Executive Director's Recommendation

Commission Meeting: October 4, 2018

PROJECT National World War I Memorial Pershing Park Washington, DC	NCPC FILE NUMBER 7682
SUBMITTED BY United States Department of the Interior National Park Service	NCPC MAP FILE NUMBER 1.23(73.10)44812
REVIEW AUTHORITY Commemorative Works per 40 U.S.C. § 8905 and Public Law 113-291	APPLICANT'S REQUEST Approval of comments on revised concept plans
	PROPOSED ACTION Approve comments on revised concept plans
	ACTION ITEM TYPE Staff Presentation

Comments on Concept Design

“L” Walkway – with scrim

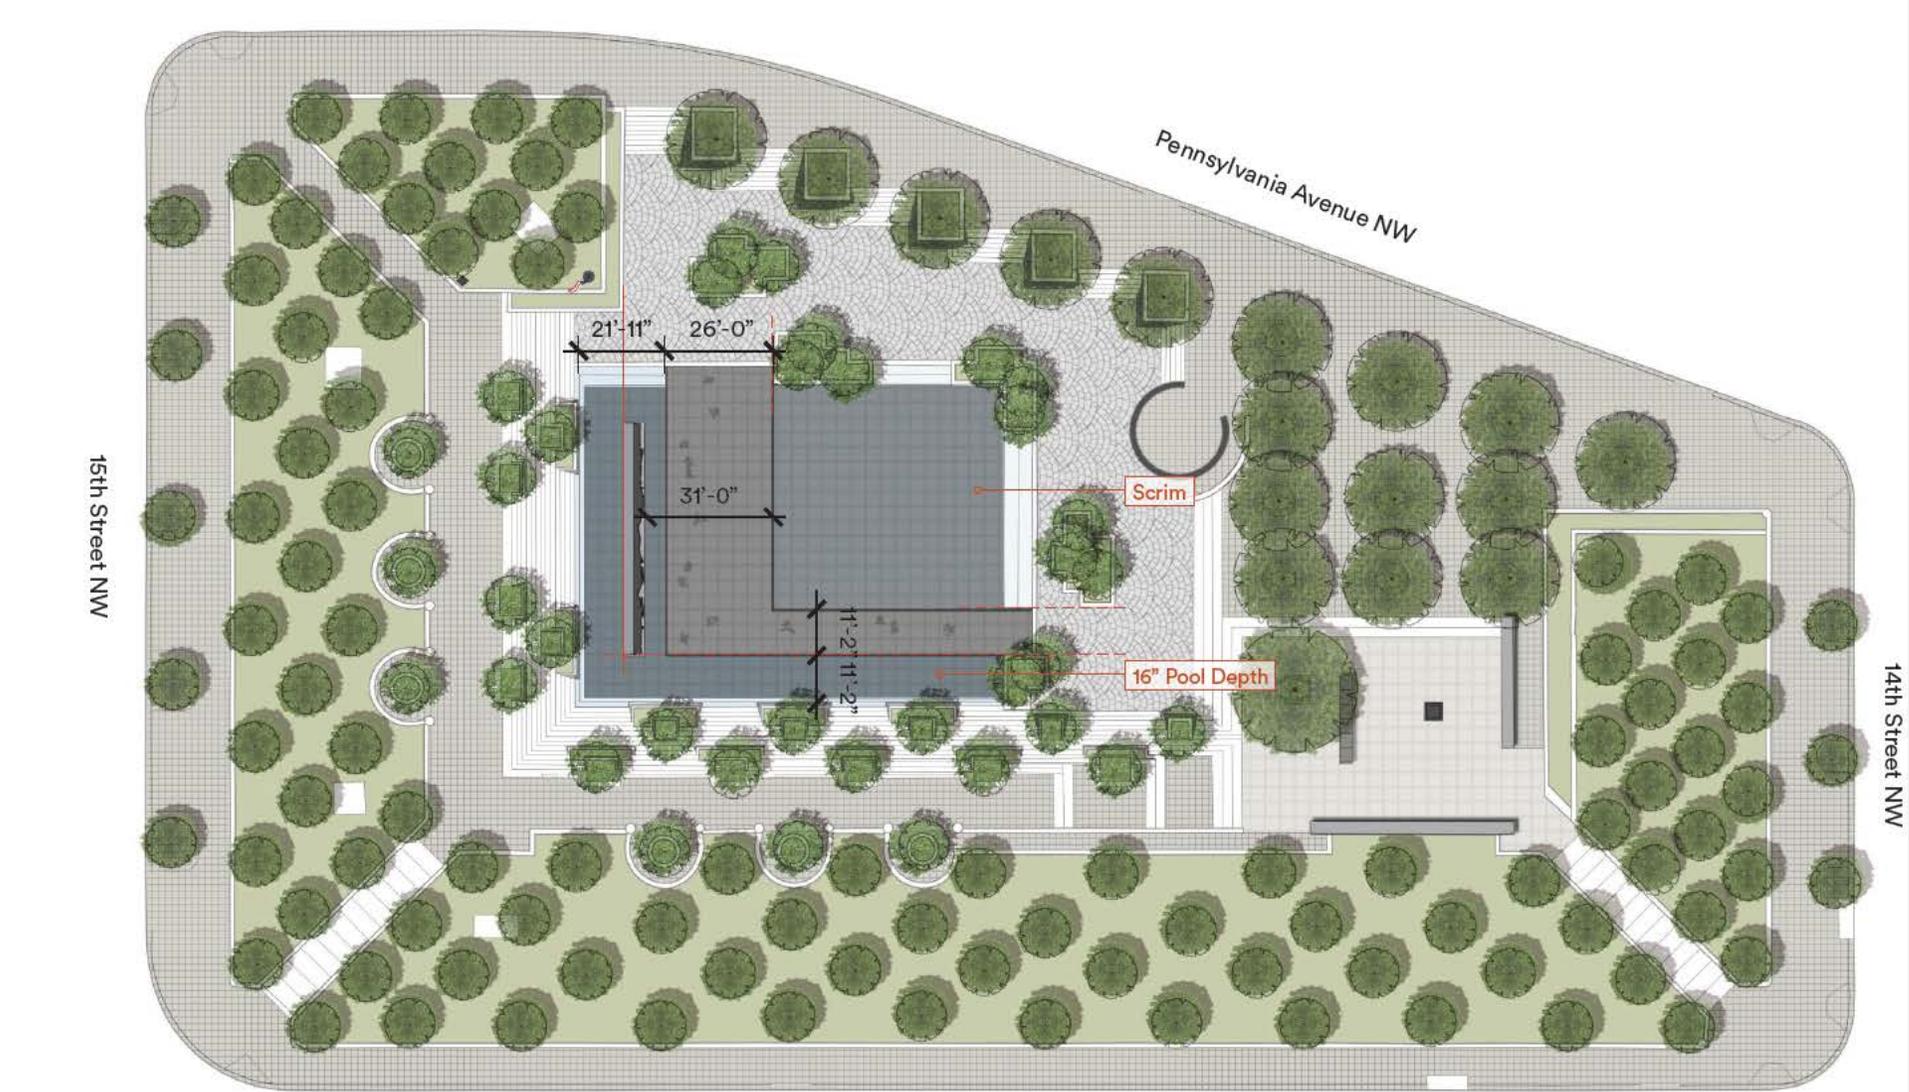
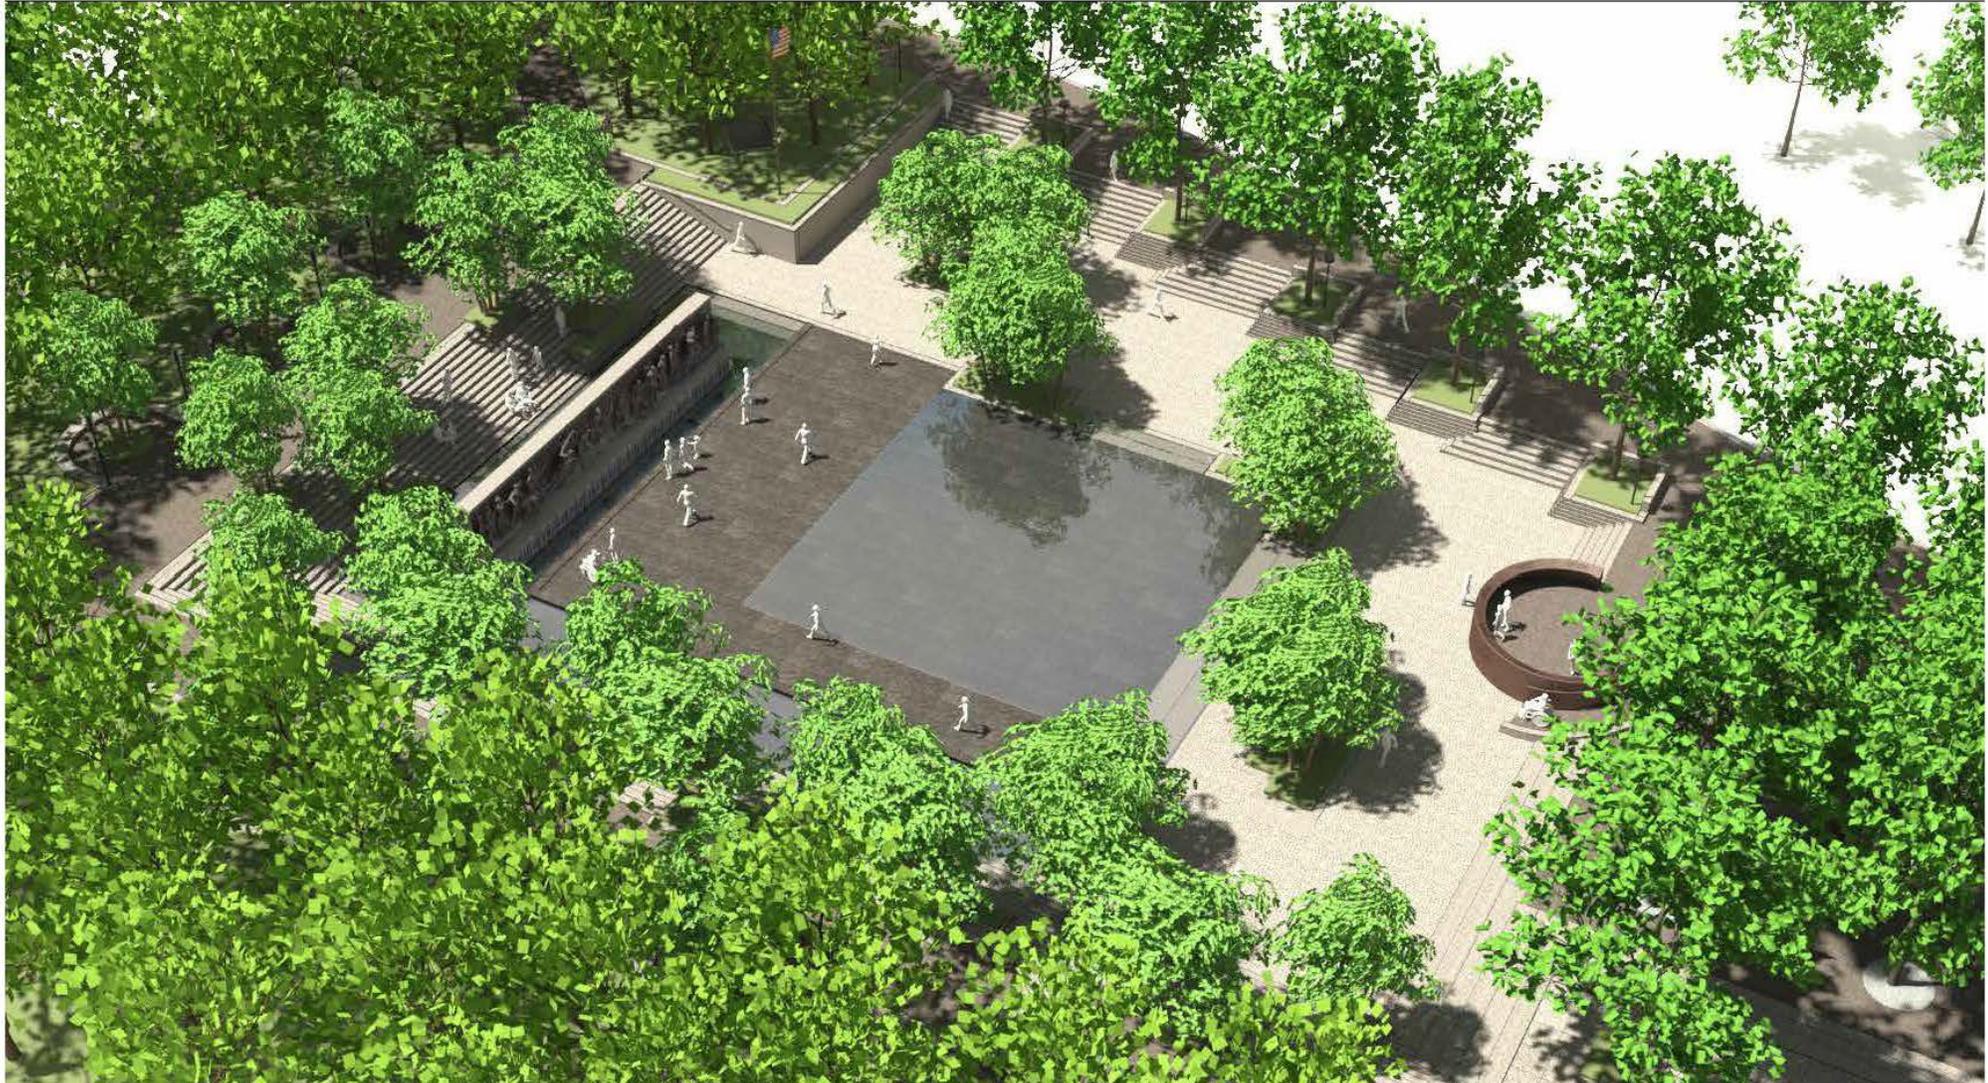
Finds the "L" Walkway with Partial Deep Pool and Scrim provides a new pedestrian connection between the eastern and northern portions of the plaza, and alters the original pool depth in the area proposed to be a scrim of water.

“U” Walkway – with scrim

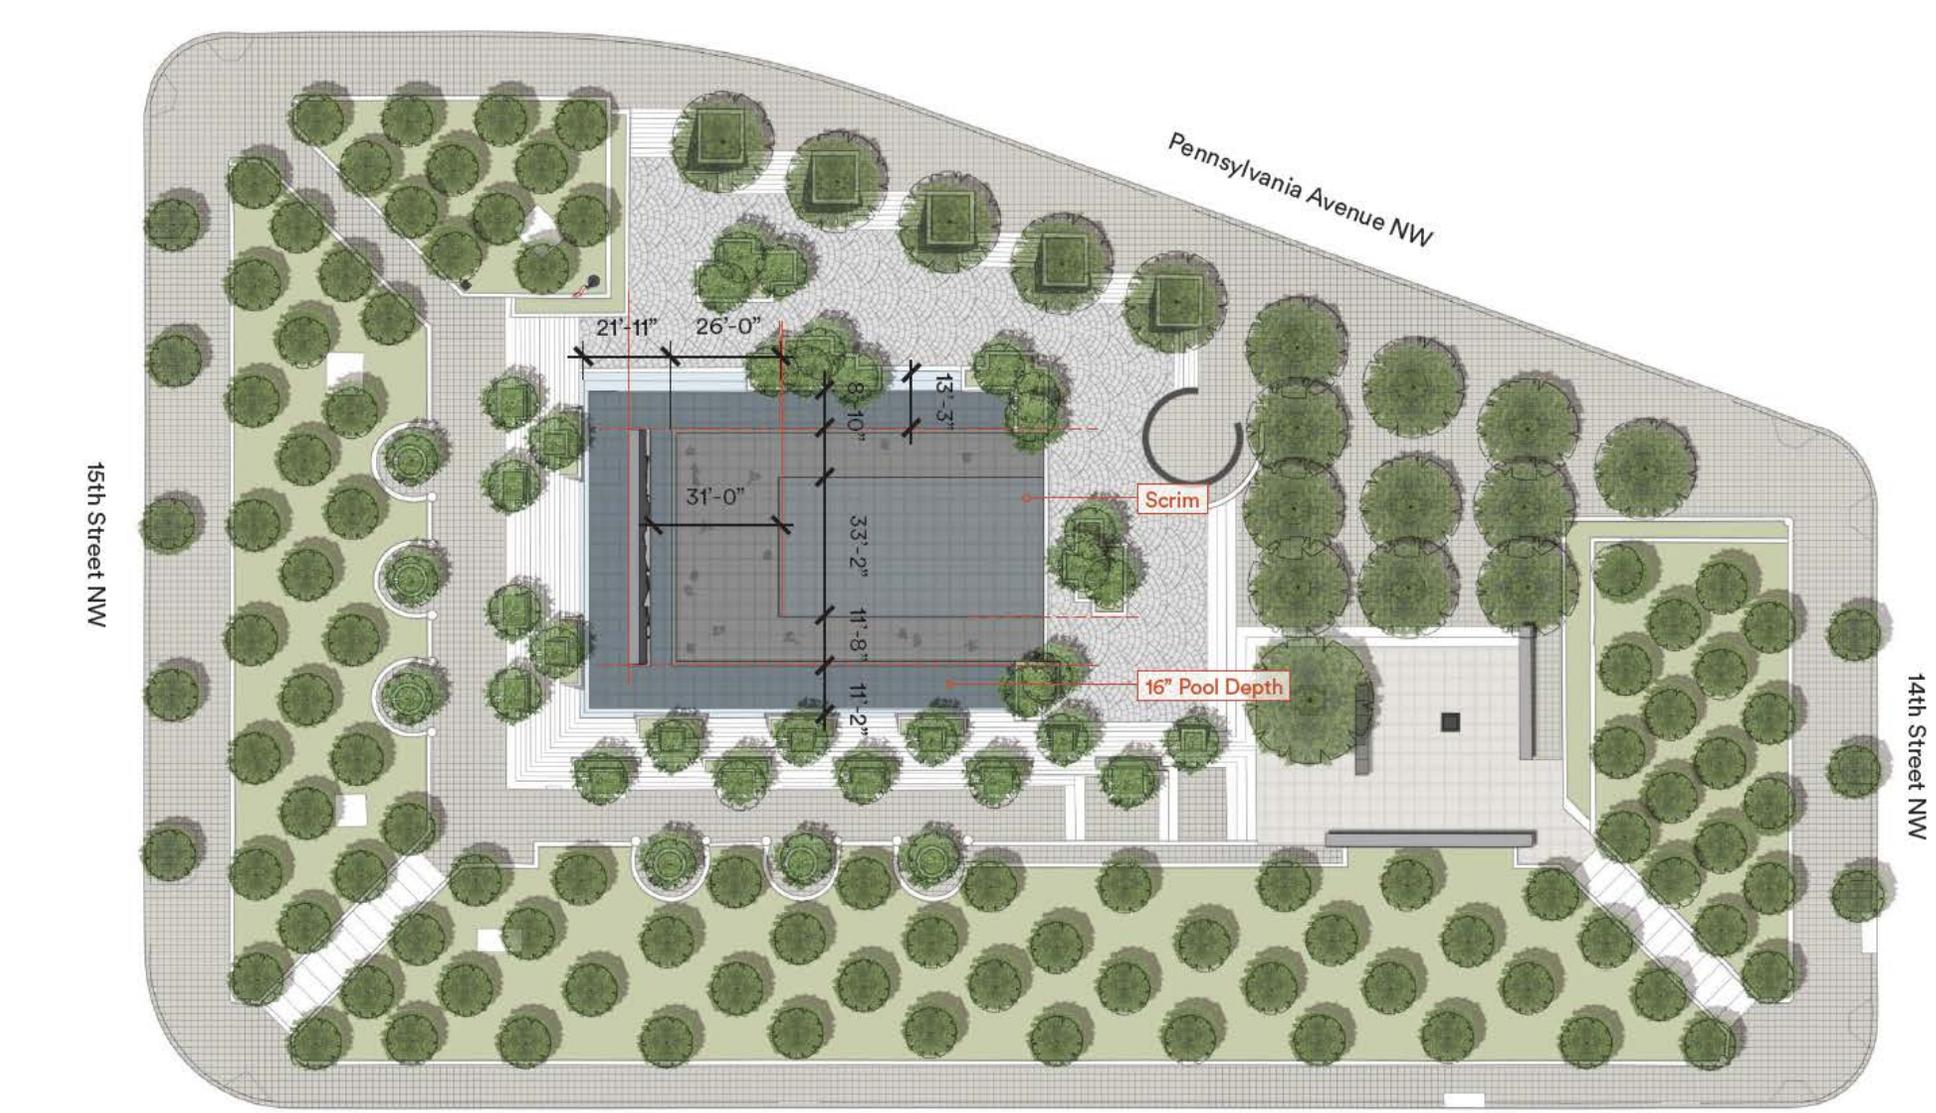
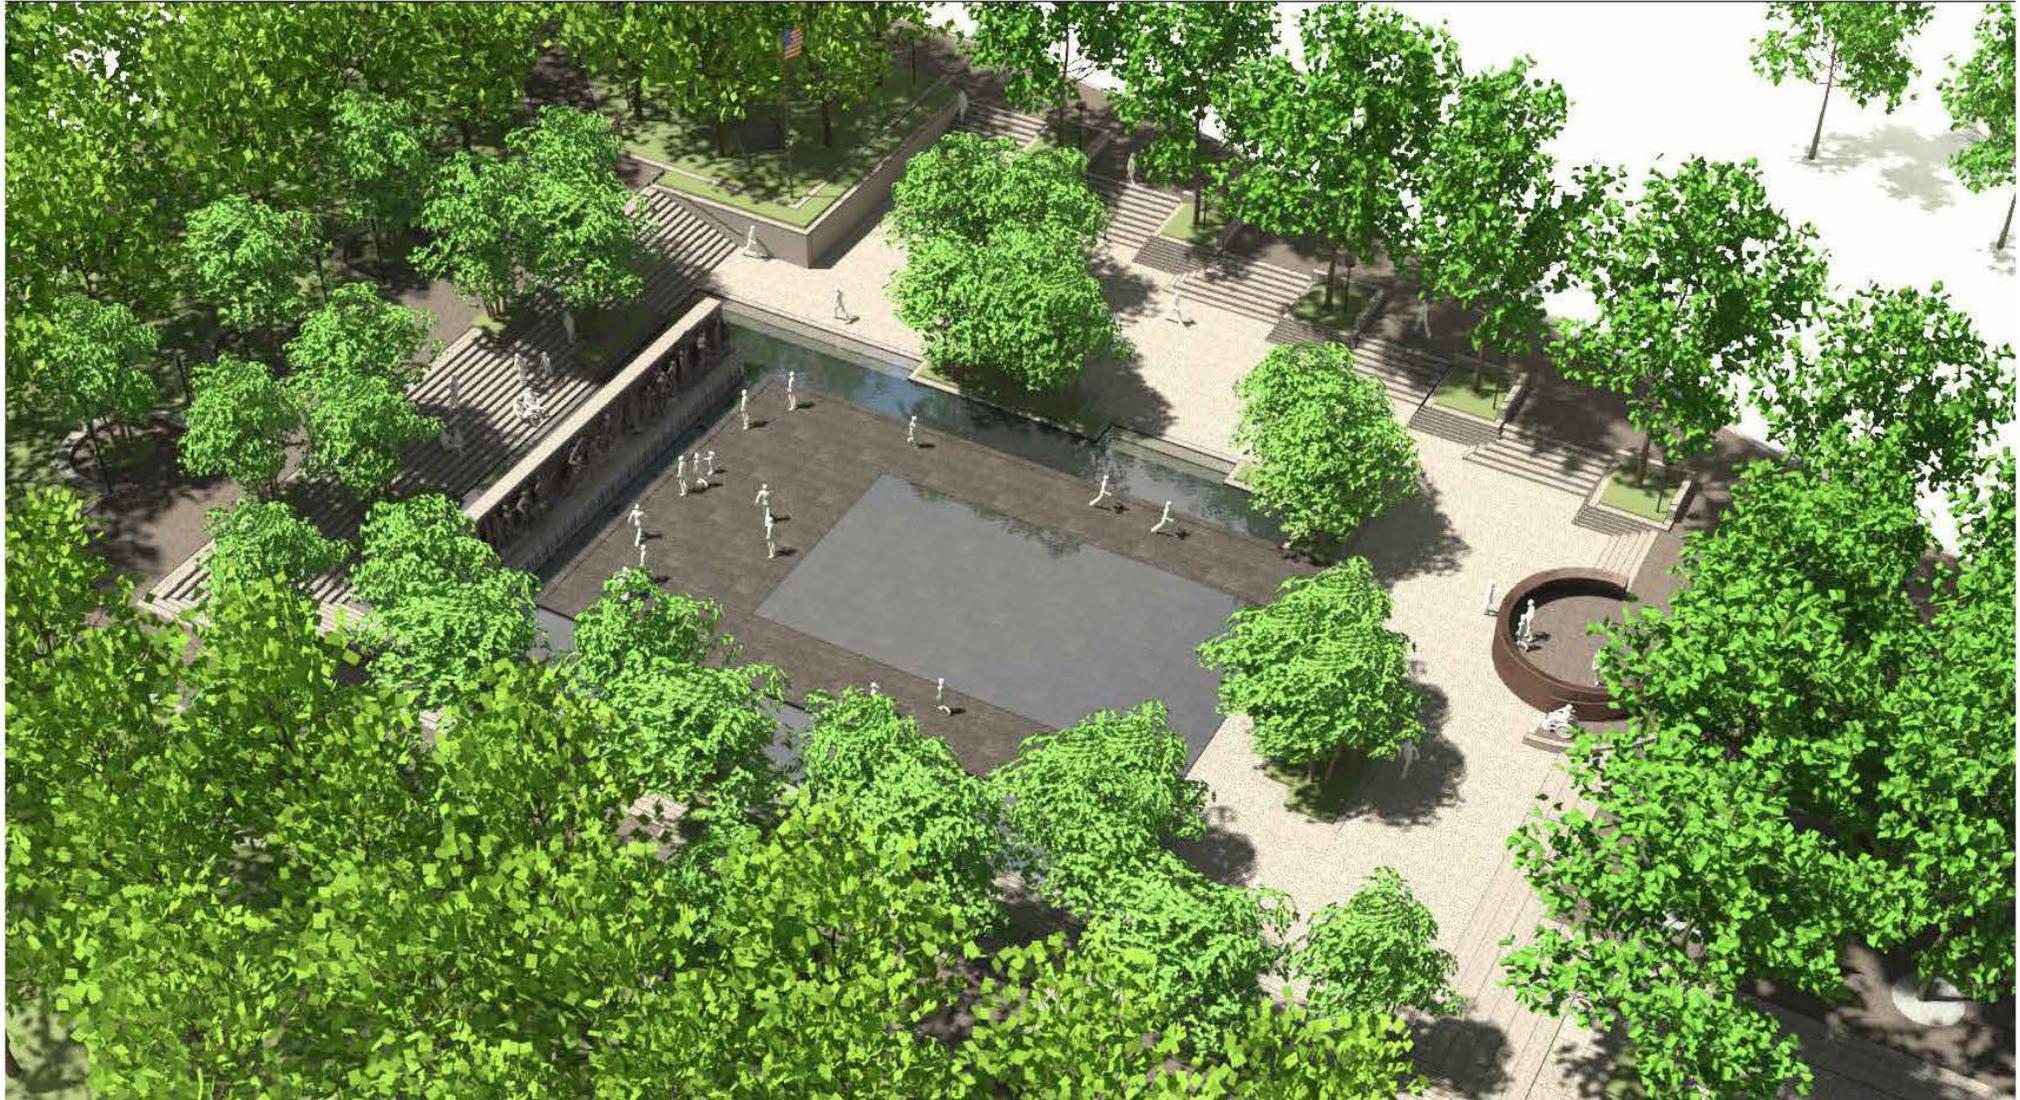
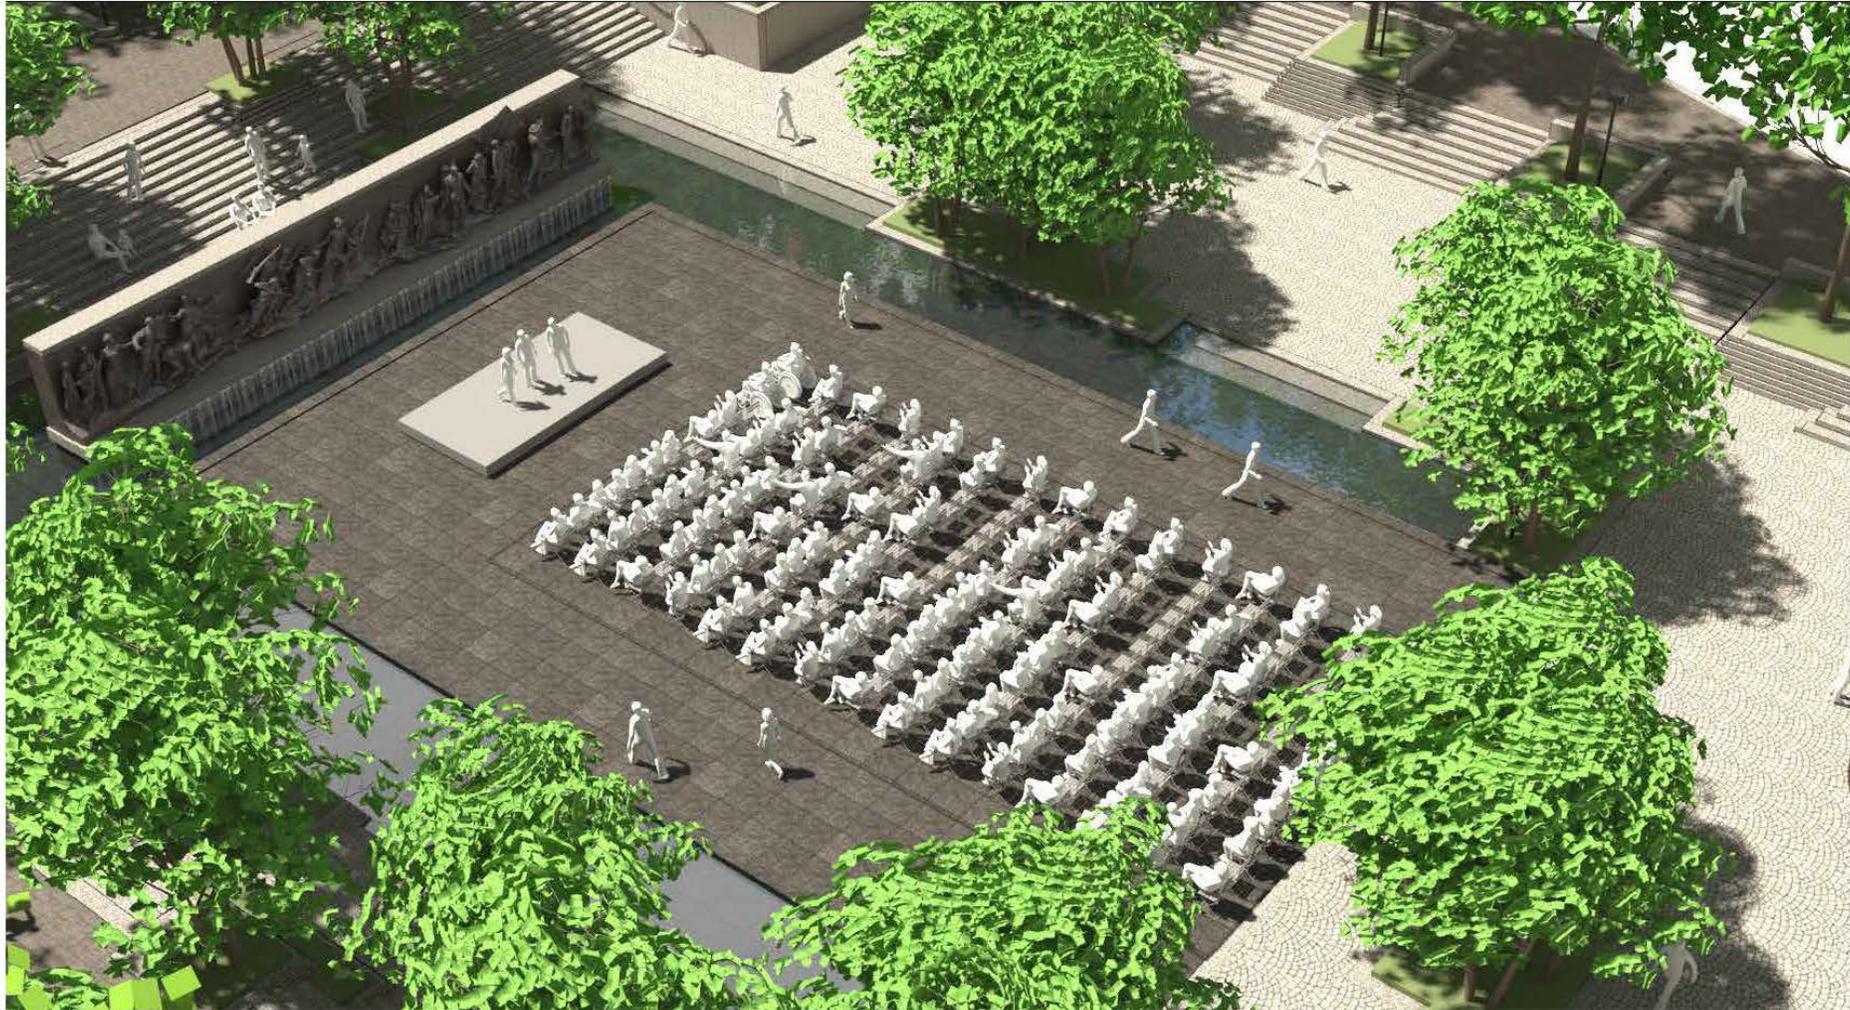
Finds the "U" Walkway with Partial Deep Pool and Scrim provides a pedestrian path that begins and ends at the eastern side of the plaza, and alters the original pool depth in the area proposed to be a scrim of water.
